Product Change Notification / ASER-06FDTY754

CCB 4882 Final Notice: Qualification of CEL-8240 GS new molding compound for selected LR8Nxxx, LR645Nxxx, LR745Nxxx, LR12Nxxx, HV992xxx and TC32Mxxx device families available in 3L TO-92 package at CRTK assembly site.

CCB 4882
Pre and Post Change Summary
PCN #: ASER-06FDTY754

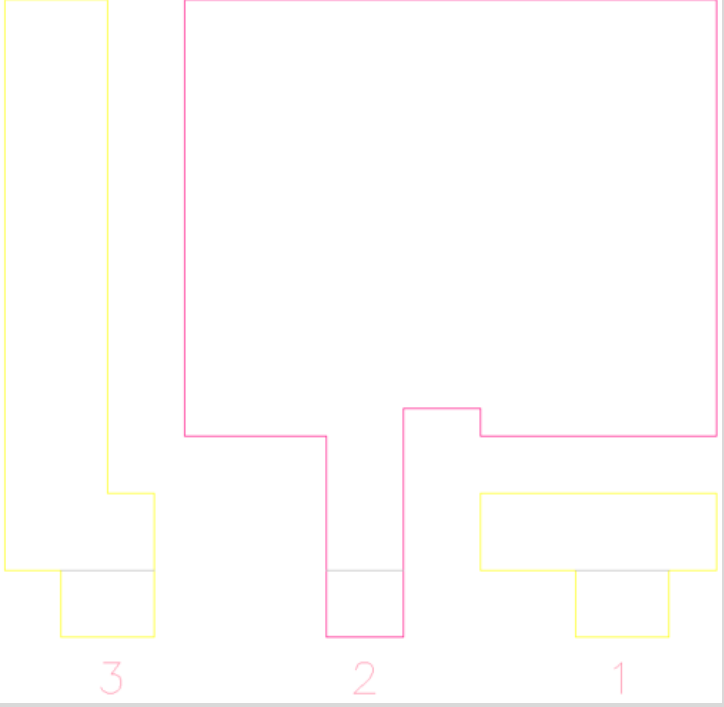
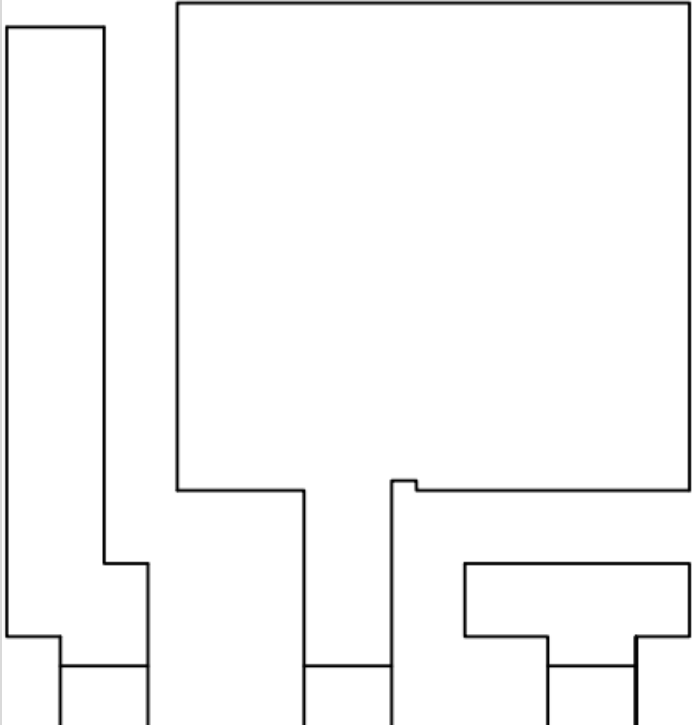
Description of Change:Qualification of CEL-8240 GS new molding compound for selected LR8Nxxx, LR645Nxxx, LR745Nxxx, LR12Nxxx, HV992xxx and TC32Mxxx device families available in 3L TO-92 package.
